CITY OF WINTER PARK PLANNING AND ZONING BOARD

Staff Report April 4, 2017

REQUEST OF DESHPANDE, INC. FOR: SUBDIVISION APPROVAL TO DIVIDE THE PROPERTIES AT 839/841/851 WEST CANTON AVENUE INTO FOUR SINGLE FAMILY LOTS, ZONED R-1A. VARIANCES ARE REQUESTED ON LOT DIMENSIONS FOR TWO OF THE LOTS WITH LOT SIZES LESS THAN THE 8,500 SQUARE FEET REQUIRED AND FOR THE FOUR LOTS WITH FRONTAGES ON WEST CANTON AVENUE SMALLER THAN REQUIRED.

SPR 1:17 Request of Charles Clayton Construction for approval to build a new two-story, single-family home located at 2072 Venetian Way on Lake Maitland.

839/841/851 Canton Avenue Lot Split Request City of Winter Park Florida

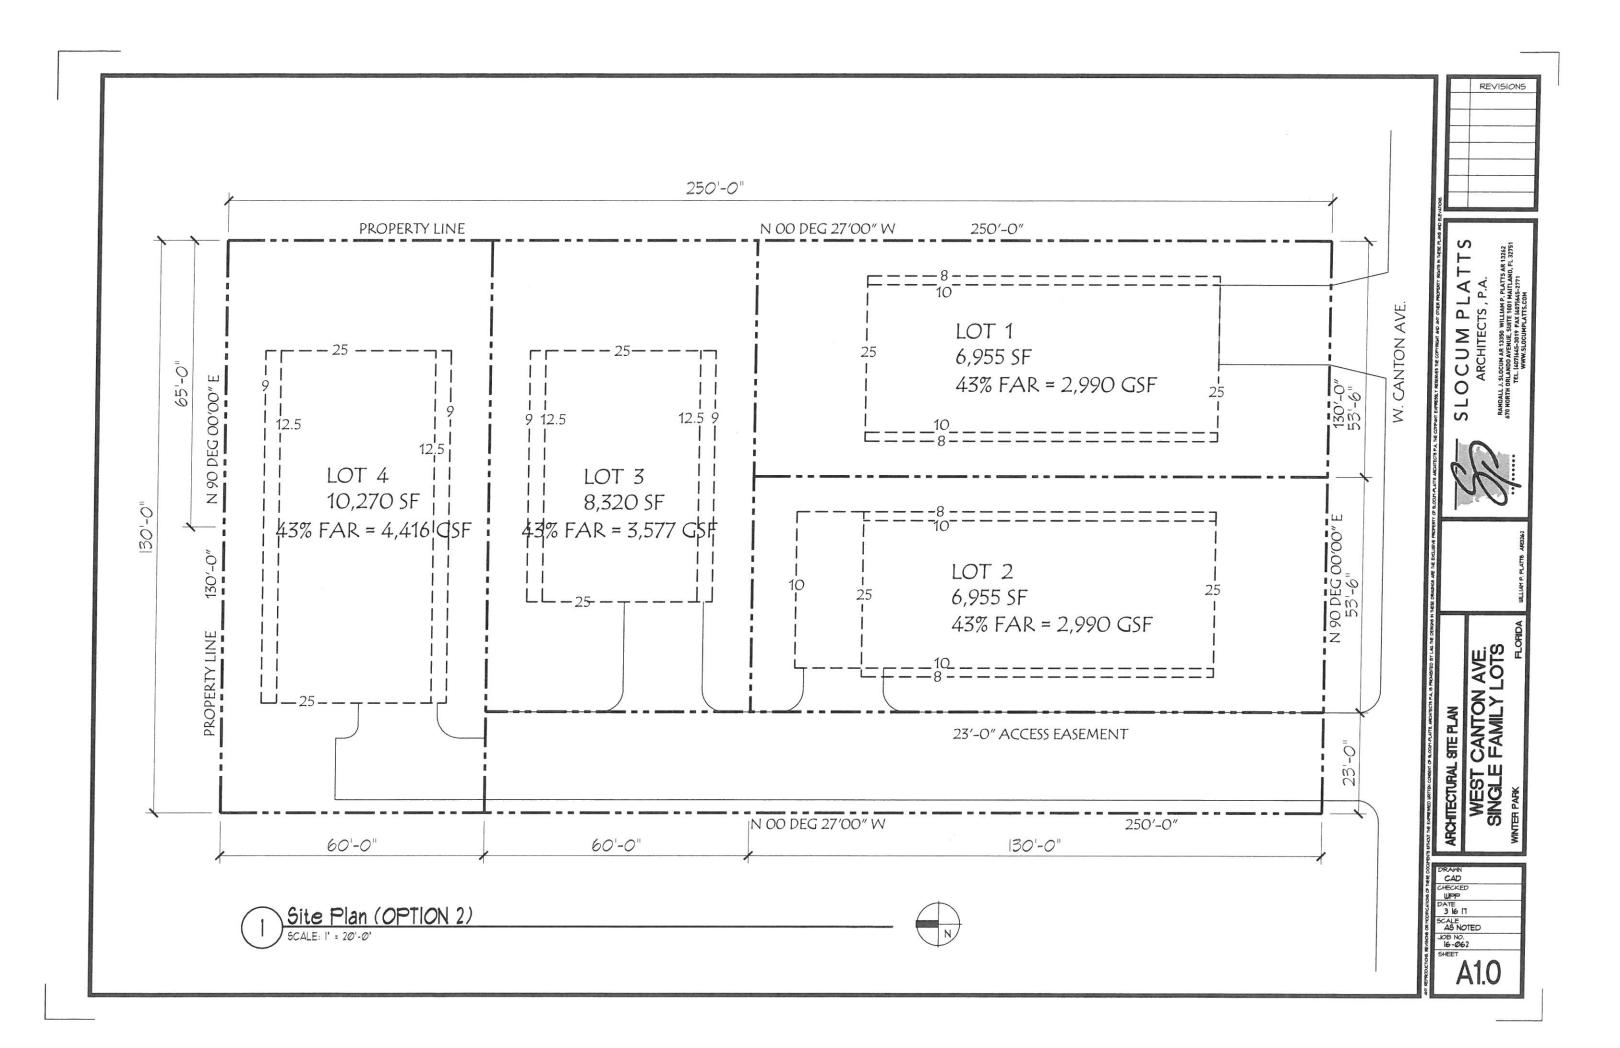
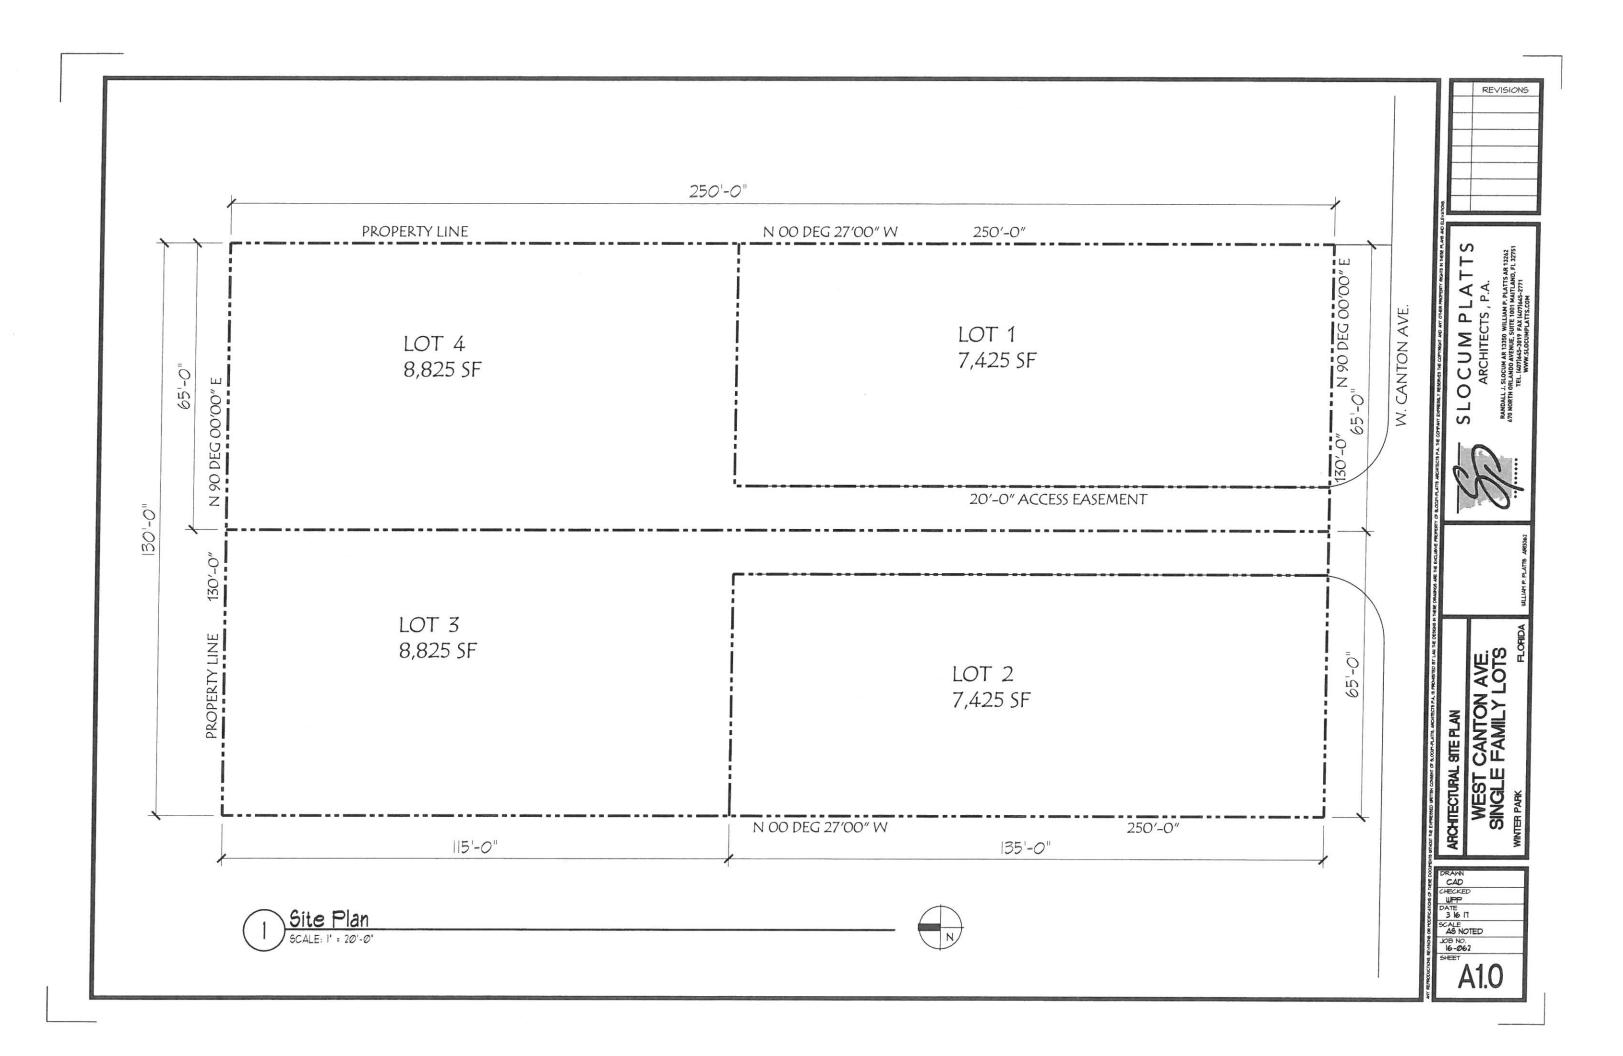
There are 75 homes within this neighborhood along Canton, Capen and Symonds Avenues, English Court, and Depugh Street with the same R-1A zoning (see attached map). The average lot width is 56 feet and the average lot area is 5,973 square feet. The median lot width is 52 feet and the median lot area is 5,227 square feet. Thus, these lots do compare favorably to the average and the median lot size and area.

SUMMARY: Based on the Zoning Test, this request does not meet the minimum R-1A lot dimension standards for either option, and in most scenarios also does not meet the land area standards, and variances are requested. However, the Comprehensive Plan test showed that this request compares favorably to the larger neighborhood.

The variances requested are to achieve a development yield of four homes/lots. Three homes/lots can be achieved with no variances. Attached is a plan that shows how three lots can be achieved with no variances. To the staff, other than the economics for the applicant, there is no compelling reason to support the variances requested.

In recognition that variances are required to subdivide these properties into four lots, the Staff Recommendation is for Denial.

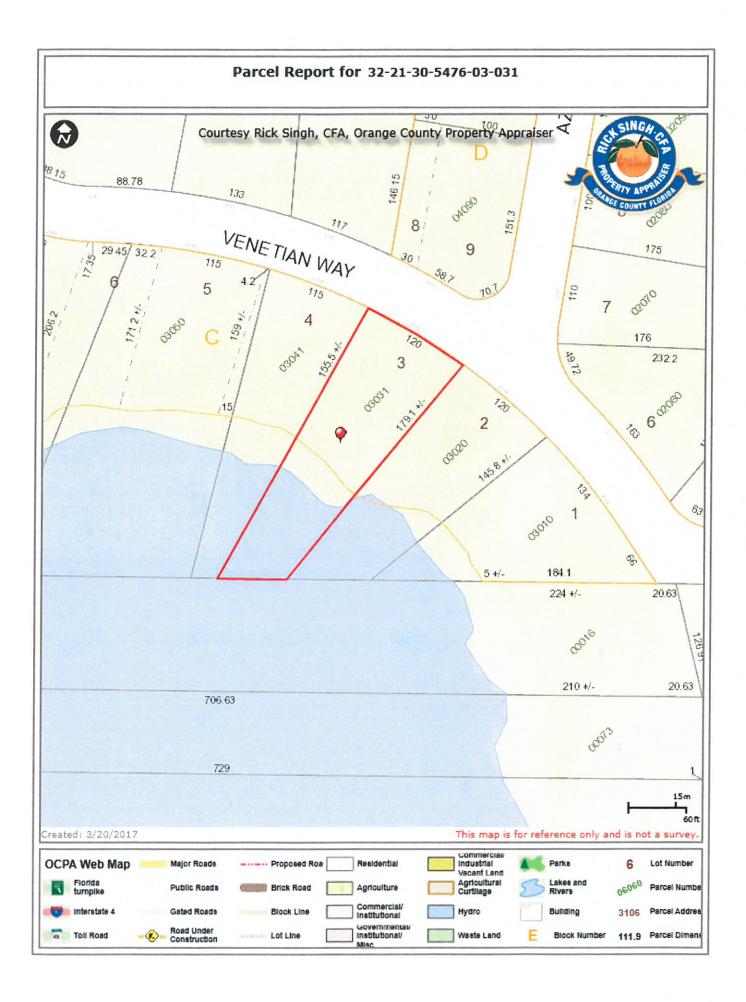
TREE PRESERVATION: The Code direction on water front lots is "to preserve existing trees to the degree reasonably possible." There are two trees located within the building footprint. The trees not located within the footprint are being preserved. The applicant met with the City's Urban Forestry department and confirmed that they would approve the removal of these trees.

VIEW FROM THE LAKE: This lot has almost no grade drop, and is relatively flat. Thus, the issues that we typically deal with about grades and retaining walls are not present in this case. The swimming pool and deck will be less than three feet in height from the existing grade of the lot.

VIEW OF NEIGHBORS: The proposed home generally follows the curvature of the lake and the building lines of the two adjacent homes, so it will not impede the views of neighboring properties.

STORM WATER RETENTION: The applicant is proposing two stormwater retention areas in the southern portion of the site, and is sized to meet the City's code requirement.

SUMMARY: Overall, the plans meet the intent of the lakefront review criteria. Staff does not see any significant concerns with the proposed home as presented.

STAFF RECOMMENDATION IS FOR APPROVAL

LEFT ELEVATION PROPOSED

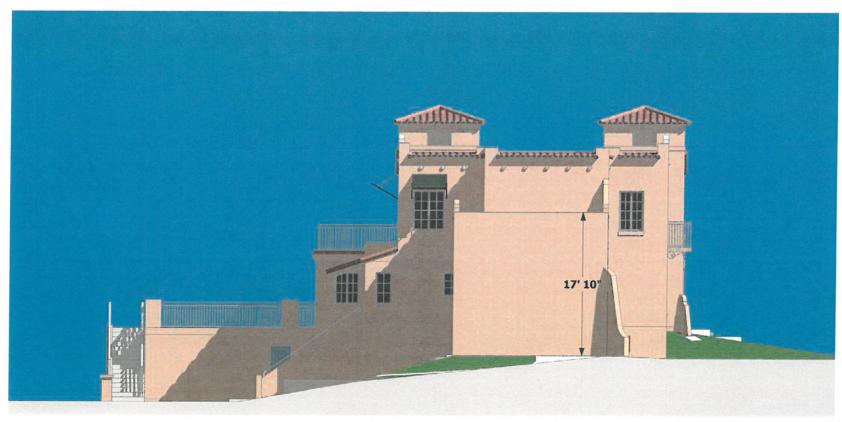
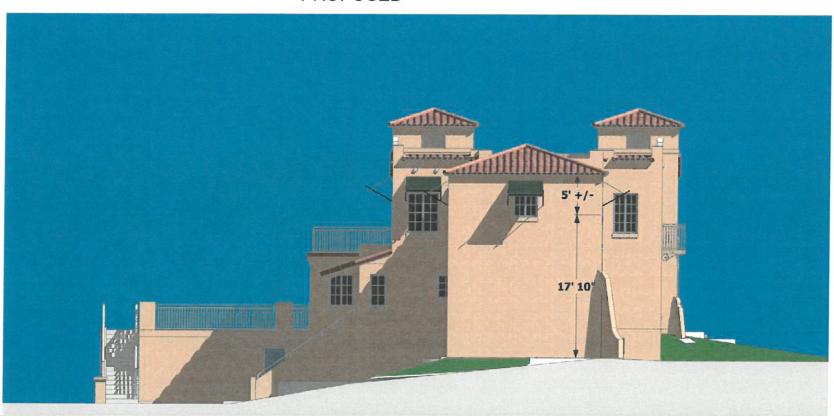
According to today's setback standards, on a lot approximately 138 feet wide, the required side setbacks are 17 feet to the first floor and 24 feet to the second floor. The existing porte cochere is located 17.5 feet from the property line, and this addition is proposed to be directly on top of the porte cochere without any step back, so a variance is required for this second story portion that is over 12 feet tall and located 17.5 feet from the property line.

VIEW OF NEIGHBORS: The proposed two-story addition will not significantly alter the lake views of the adjoining neighbors. However, as previously mentioned, the request does require a western side setback variance and the affected neighbor at 227 Virginia Drive has provided a letter of no objection to this request.

SUMMARY: Staff is in support of the variance required for the proposed two-story addition. The alternative locations for this addition would be more intrusive to the lakefront views, add more impervious coverage to the lot and potentially require tree removals. Overall, with the attached letter from the affected neighbor, the plans meet the intent of the lakefront review criteria. Staff does not see any significant concerns with the proposed home as presented.

STAFF RECOMMENDATION IS FOR APPROVAL
